Public Forum

D C Committee A

Wednesday 6th March 2024

STATEMENT BY BRISTOL CIVIC SOCIETY re 23/02827/F | Demolition and redevelopment to provide co-living units and purpose built student accommodation, (PBSA) etc | Premier Inn, The Haymarket Bristol BS1 3LR

VERIFIED VIEWS

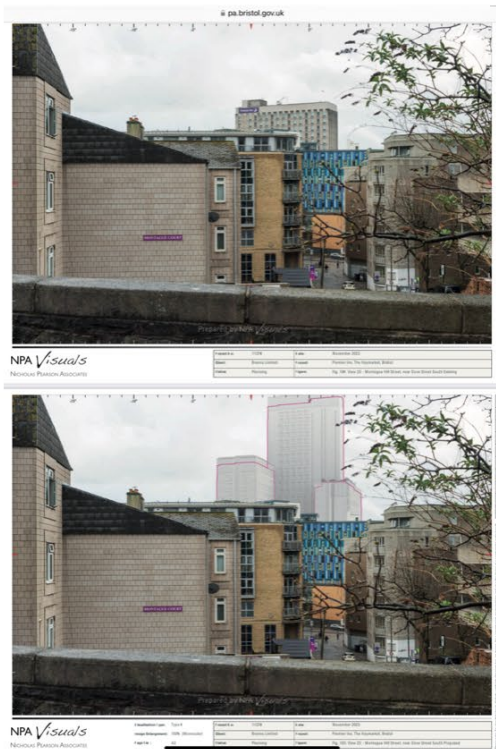
Red outline where shown is to illustrate applicant's response to concerns about height

The application's heritage benefit: 'opening up views of Scottish Presbyterian Chapel'...

Combined impact

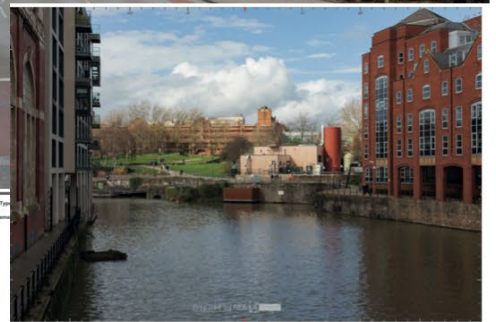
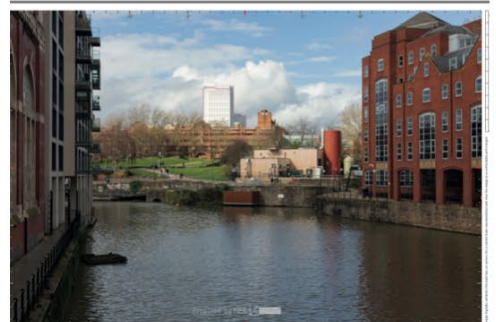
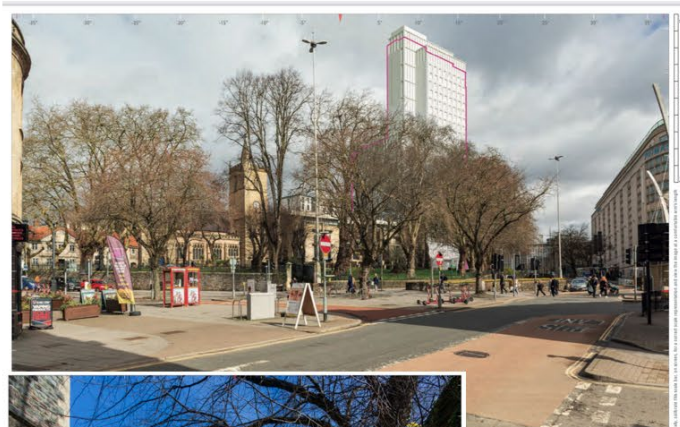
Making the Premier Inn look neighbourly....

Welcome to downtown Bristol..

And with the Debenhams redevelopment...

STATEMENT re. 23/02827/F – Premier Inn – Planning Meeting of 6th March 2024
from Hamilton Caswell, Christmas Steps Arts Quarter (Residents & Traders)

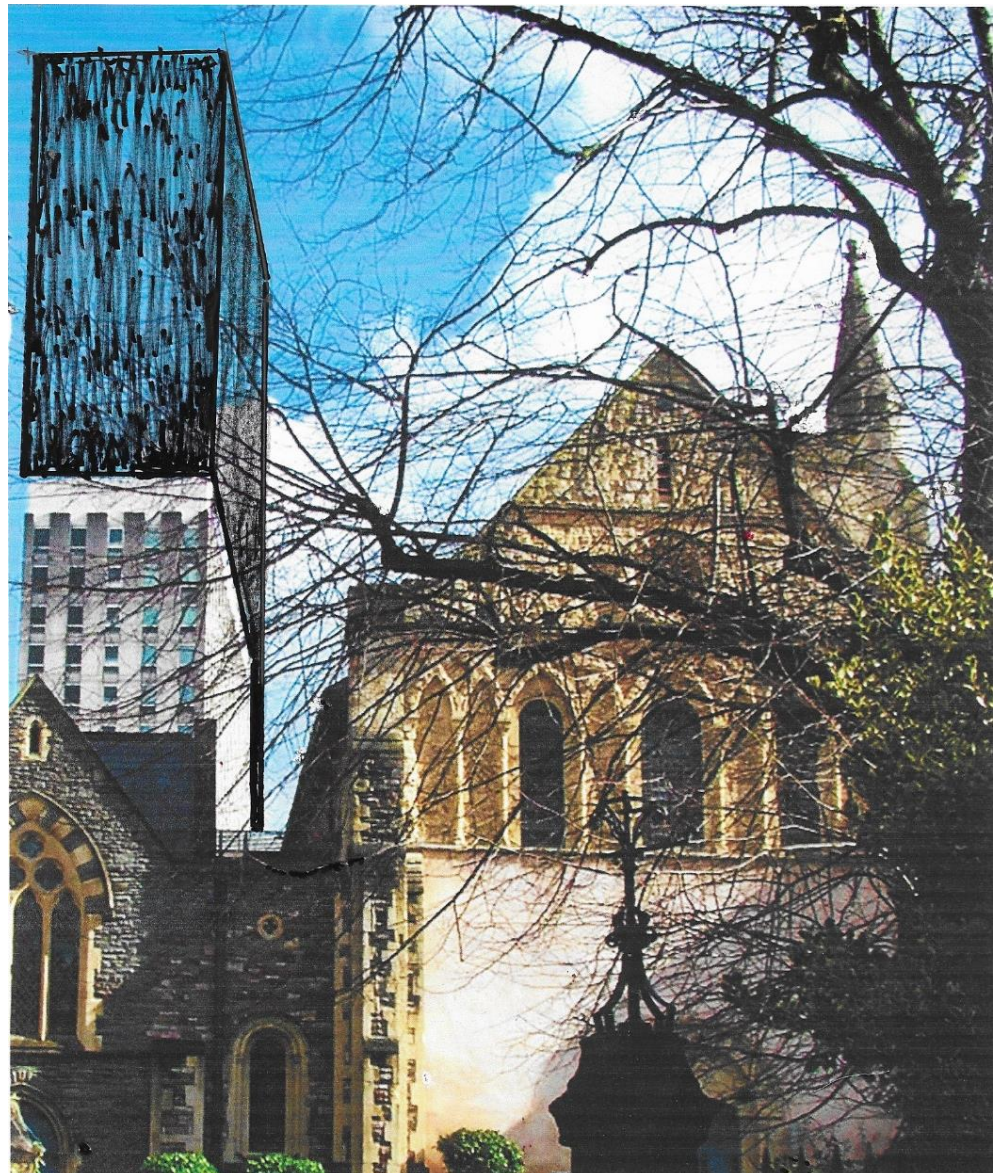
- 4. Harm to the setting of Listed Buildings**

We illustrate Bristol's oldest working building – Grade 1 listed St. James Priory built 1129 with the existing Premier Inn just behind and the extra height of the proposed gigantic 30-storey tower shaded-in. It would overwhelm and dwarf St. James Priory and would harm the setting of other nearby listed buildings - Fripp's Chapel, the Georgian Dental Hospital plus the many listed buildings in the adjacent Stokes Croft and Brunswick and Portland Square Conservation Areas.
